Architectural Review
and Historic Preservation Board
Agenda Report

File: AR 16-03

RE: Dr. Park's Office, 2505 Valhalla Place, APN 016-070-038

SITE PLAN

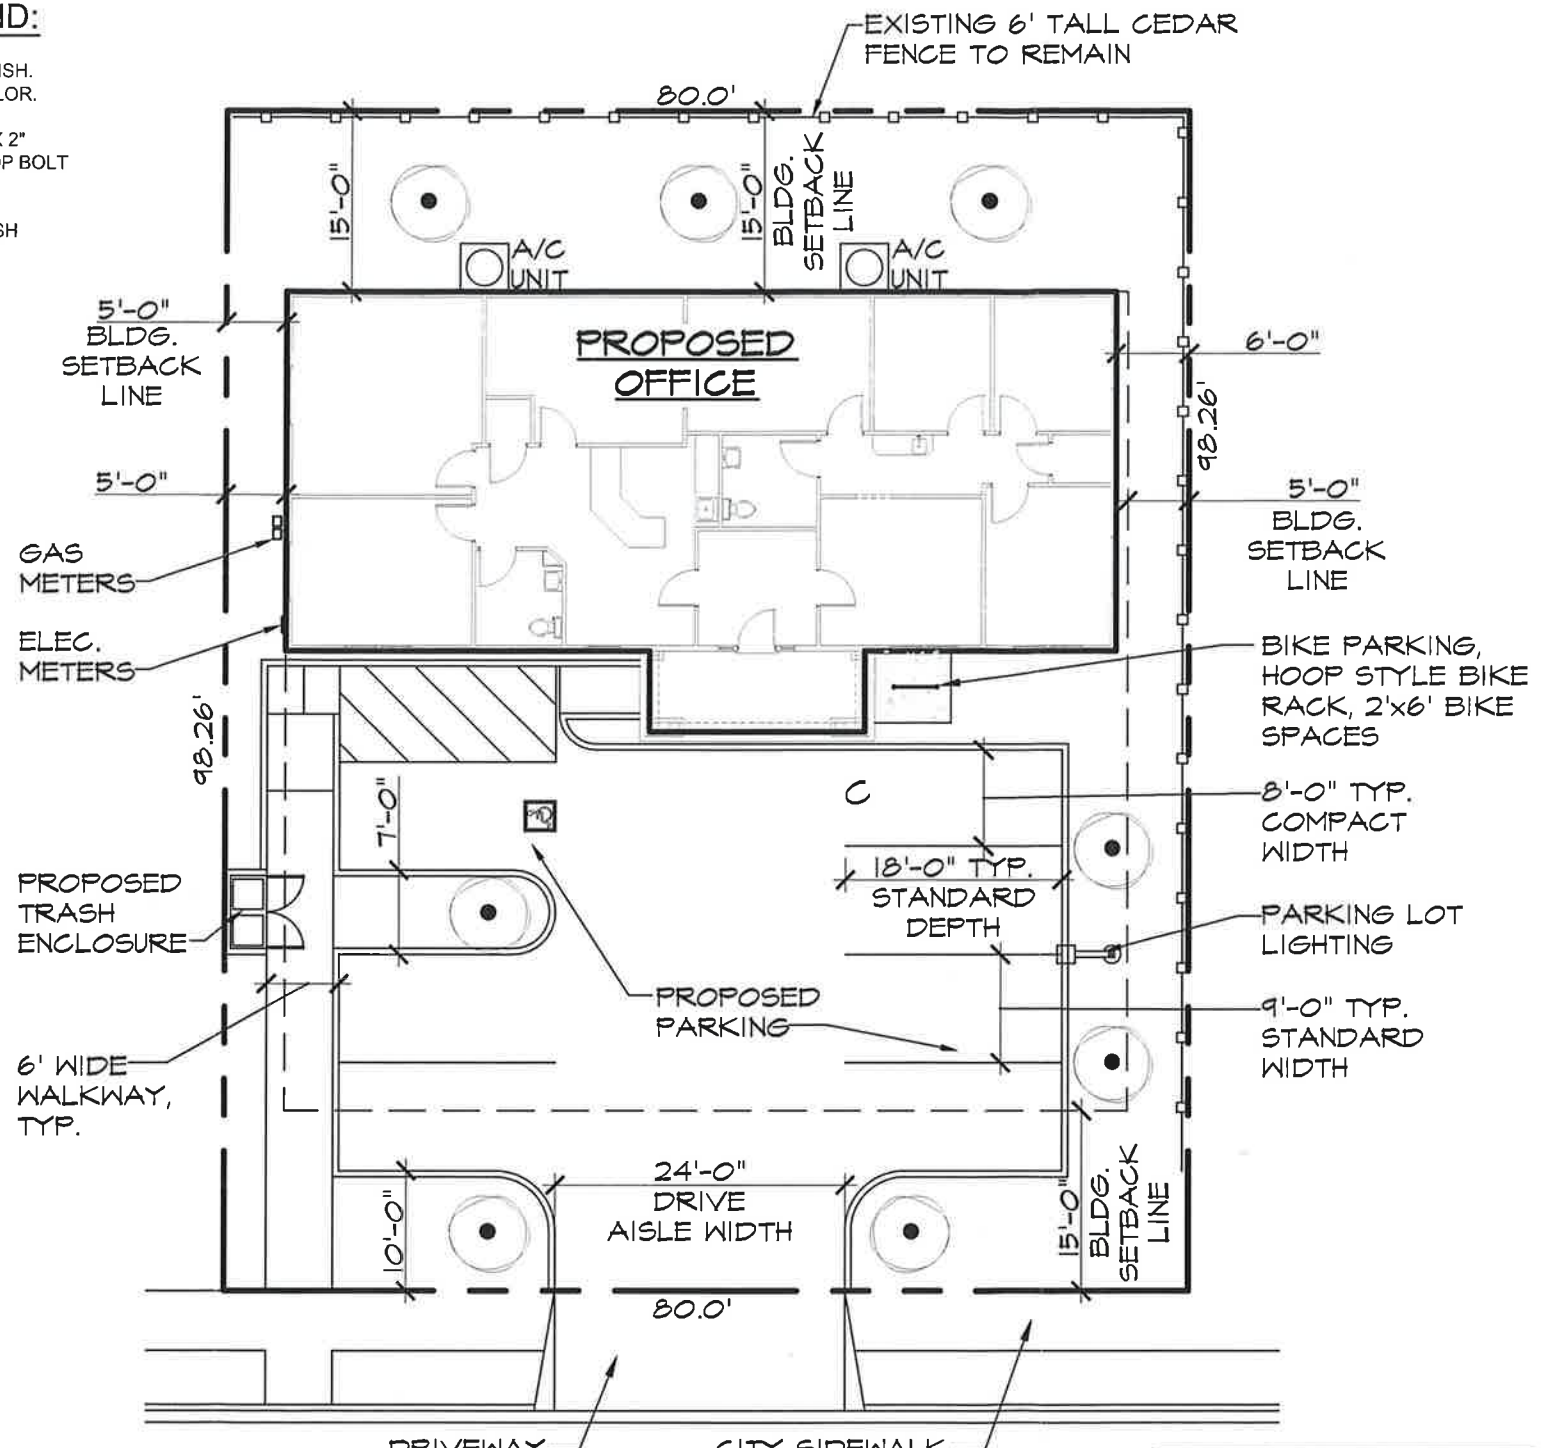
Currently vacant, the site plan calls for a new parking area located 10-feet back from the front property line with the new office structure behind. Vehicle access would be provided by a centrally-located driveway leading to a 7-space parking area, which meets Chico Municipal Code (CMC) requirements (See Site Plan, **Attachment C**). The majority of public frontage improvements were installed with the subdivision improvements.

To achieve better consistency with DGs 1.1.14 and 1.1.15, conditions are recommended to add architecturally-consistent screen walls, 3-4 feet in height, between the parking area and front sidewalk, and to provide a structural cover over the bicycle parking area. Conditions are also recommended to replace the white vinyl windows with a color that better-matches the proposed color scheme. Because the medical office use is not particularly neighborhood-serving, it is somewhat justified for the site design to be automobile-oriented. Therefore, with conditions to improve DG consistency, staff supports approval of the project.

Discuss the trash enclosure location with the architect to determine if it might be better placed nearer to the front of the property where trash pick-up will occur, and at the same time offer a screen to views of the parking lot. Condition as necessary.

2. Provide a structural screen for the parking area, at least 15 feet in length and three to four feet in height, matching the style of the trash enclosure walls. Signage may be allowed on the screen wall, in compliance with City signage regulations.

3. Provide a structural cover over the bicycle parking area, or relocate the bicycle parking to a covered location within 20 feet of the front building entrance.

PRELIMINARY LANDSCAPE PLAN

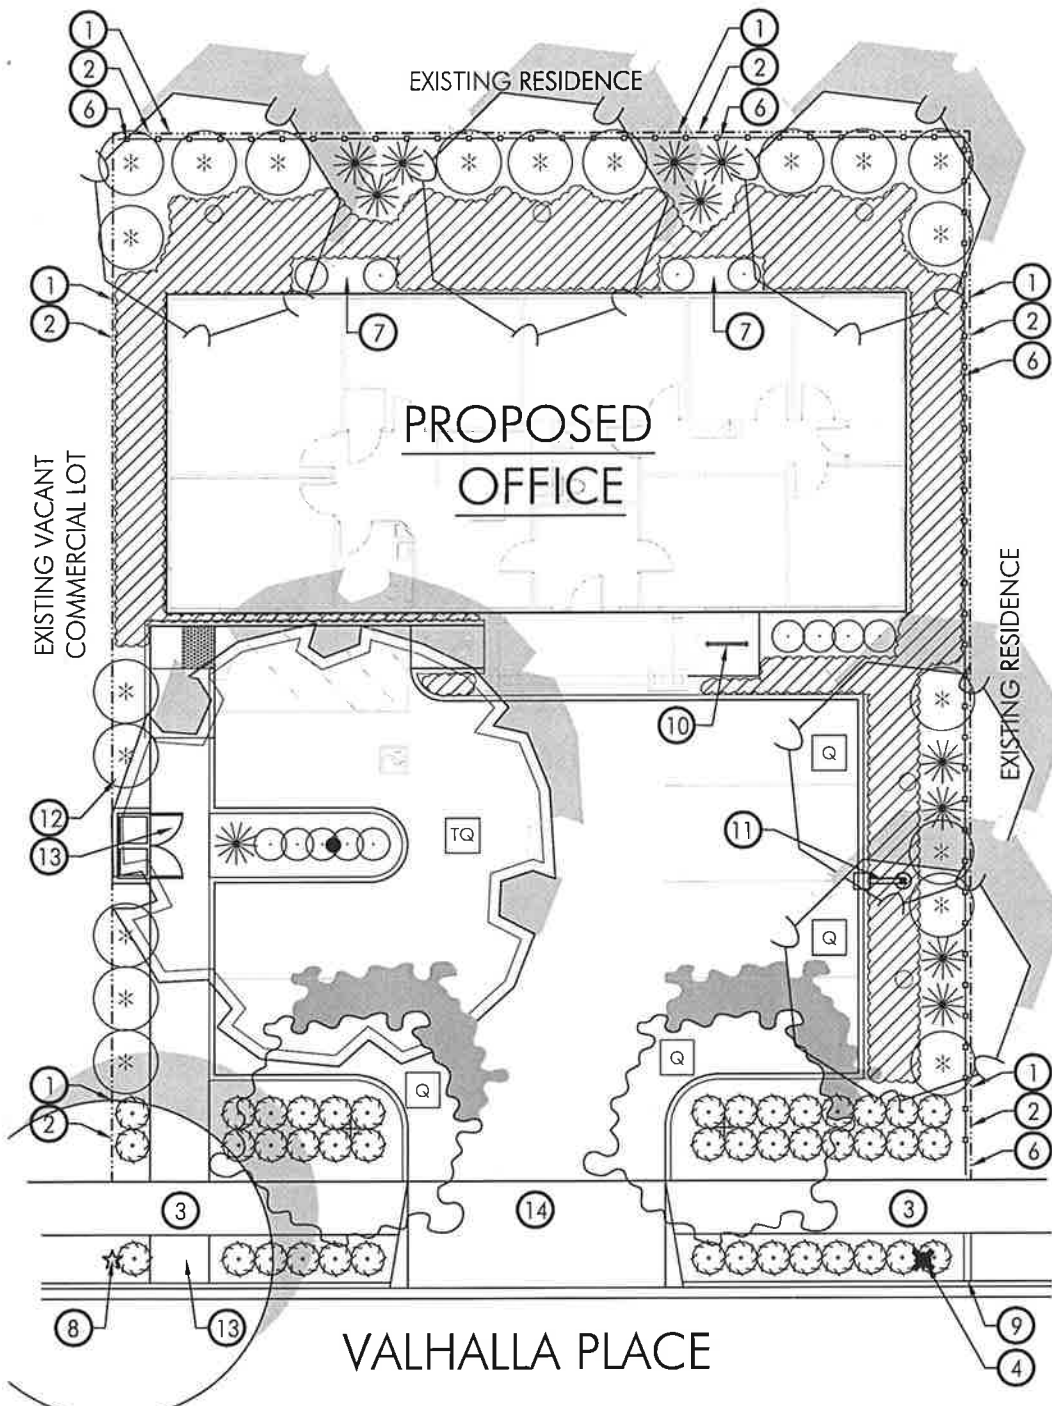
Landscaping is planned around the perimeter of the site, with one large Chinese pistache tree providing most of the parking lot shading(see Landscape Plan, **Attachment D**). Additional accent trees (crepe myrtles and strawberry trees) are proposed in smaller planting areas. Shrubs and groundcover are also proposed to in the parking lot setback area and at various perimeter locations.

As of July 1, 2015 the City of Chico is responsible for implementing Low Impact Development (LID) requirements as part of the State Water Resource Control Board's MS4 General Permit. Because of this new requirement, staff recommends a condition of approval that will allow flexibility in the final landscape plan to ensure the project will be in conformance with LID standards.

6. The proposed landscape plan may be modified as necessary to comply with Low Impact Development (LID) requirements, as promulgated under Chico Municipal Code Section 15.50.
7. All wall-mounted utilities and roof or wall penetrations, including vent stacks, utility boxes, exhaust vents, gas meters and similar equipment, shall be screened by appropriate materials and colors. Adequate screening shall be verified by planning staff prior to issuance of a certificate of occupancy.

ATTACHMENT E

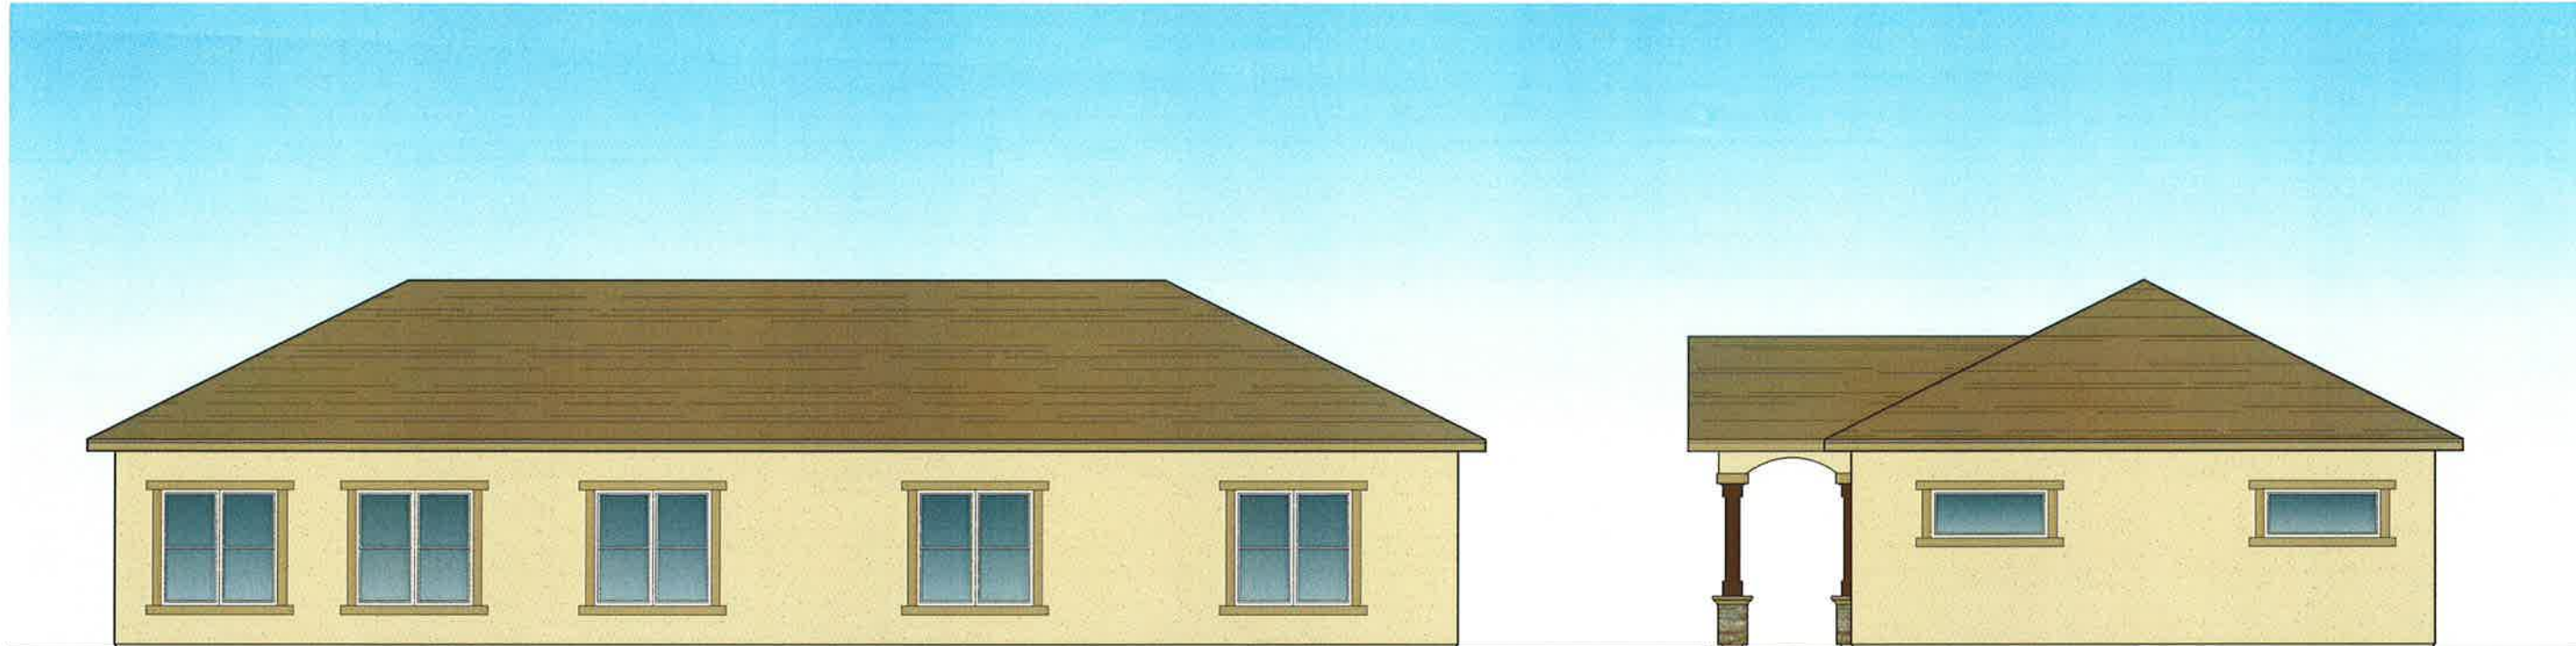
The proposed office building is a simple, stucco structure with hipped rooflines, stucco trim around all windows and doors, and a prominent front entry gable facing the entry drive and parking area (see Elevations, **Attachment E**). The gabled entryway would have paired columns with bases wrapped in stucco stone. Windows appear to be white vinyl with grid dividers.

Considering Design Guidelines that encourage incorporation of recognizable design elements related to the immediate neighborhood and greater Chico area (DGs 1.1.11, 1.2.21 and 1.1.34), discuss if adding or modifying architectural features is necessary for the Board to make the required findings for approval. Nearby residences include trellis features, river rock wainscot, and outlooks on gable-ends facing the street. Replacing the ledge-stone with river-rock pattern would enhance consistency with material used on the area. Adding trellis

features on either side of the entry feature could better-relate the project to residences in the immediate area, and would afford an opportunity to subtly cover the bicycle parking area. Modifying the roofline to include Dutch gables at the hipped ends of the building would add exposed gables, which are abundant on houses along Valhalla Place.

4. Replace the white vinyl windows with colored vinyl window frames (not white) that complement the approved color scheme of the office structure.
5. All new exterior lighting shall be full cutoff and directed onsite such that no light shines offsite and luminaires are minimally visible from adjacent properties. Parking lot light fixtures shall not exceed a total height measured from grade of 12 feet.
